PCN# 20121221001

Fix unstable operation with PLLM at 600 MHz on MityDSP-6711 Family of System On Modules

PCN Number: 20121221001
PCN Date: December 21, 2012
Title: Fix unstable operation with PLLM at 600 MHz
Contact: Bill Halpin
Phone: (315) 425-4045
Ship Date: 12/01/2012

Figure 2 Clock Distribution with change applied

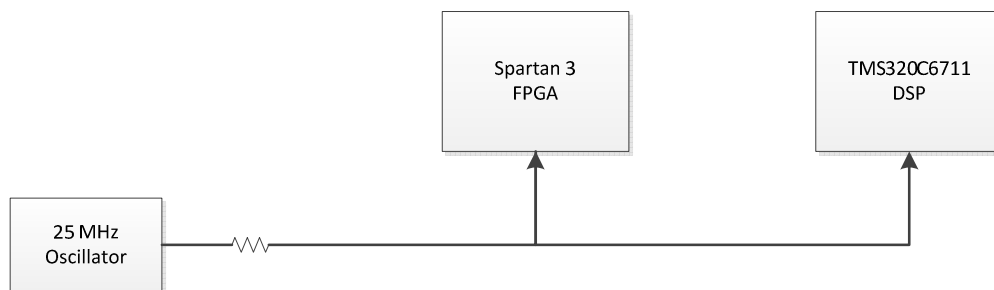
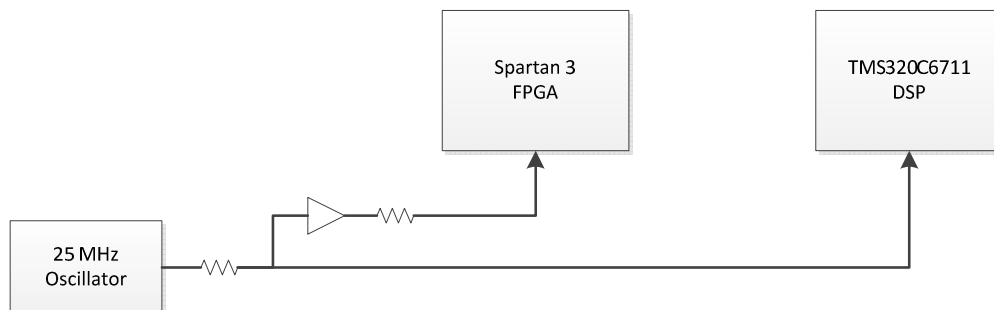
The distribution of the on-board 25 MHz oscillator clock to the FPGA and DSP was changed from what is shown in Figure 1 to that shown in Figure 2.

Recent production runs of MityDSP-6711 and MityDSP-6711 XM processors exhibited instability in the processor phase locked loop circuit. The instability presented as a rapid shift in processor clock frequency (the PLLM output) for approximately 1 to 2 microseconds, long enough to cause the FPGA digital clock manager (DCM) conditioning the EMIFA clock to break lock. This resulted in errors in communication between the DSP and the FPGA on the module.

The root cause of this issue was determined to be a combination of a suboptimal design (the 25 MHz clock source net was bifurcated, feeding both the FPGA and the DSP) and a change in the DSP manufacturing process (the clock input pin

bandwidth increased in sensitivity to as high as 4 GHz) as well as production variances in the FPGA clock input impedance.

By isolating the clock paths as shown in Figure 2, the instability due to reflections in the split clock net was removed.
